UNITED STATES PATENT AND TRADEMARK OFFICE

APPLICATION NO.	FILING DATE	FIRST NAMED INVENTOR	ATTORNEY DOCKET NO.	CONFIRMATION NO.
10/671,629	09/29/2003	Kyoung Ho Kim	1594.1244	6232

Office Action Summary

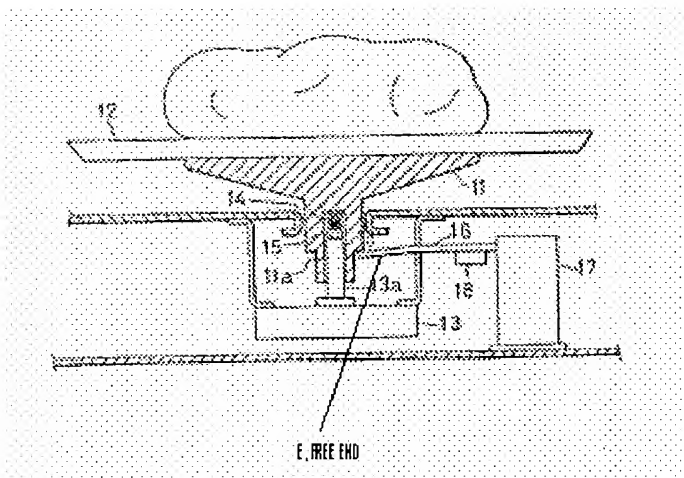
Claims 1-2, 6, 8-13, 17-18, 20 and 40 are rejected under 35 U.S.C. 102(b) as being anticipated by Hisaya (JP59215519A). Hisaya discloses cooking utensil comprising a weight detecting unit (18) supported at an end thereof, and detecting a weight according to a force applied to a free end (E, figure below) thereof; and a support unit (17) to support the weight detecting unit.

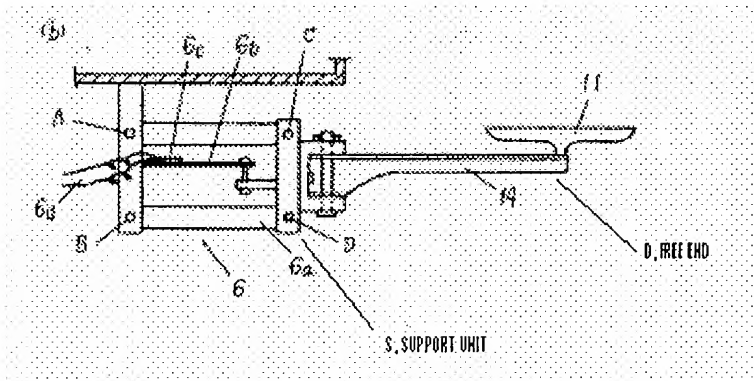
3. Claims 1-2, 9-13 and 20 are rejected under 35 U.S.C. 102(b) as being anticipated by Masaaki (JP57155035A). Masaaki discloses a microwave heater

comprising a weight detecting unit (6) supported at an end thereof, and detecting a weight according to a force applied to a free end (D, figure below) thereof; and a support unit (S) to support the weight detecting unit.
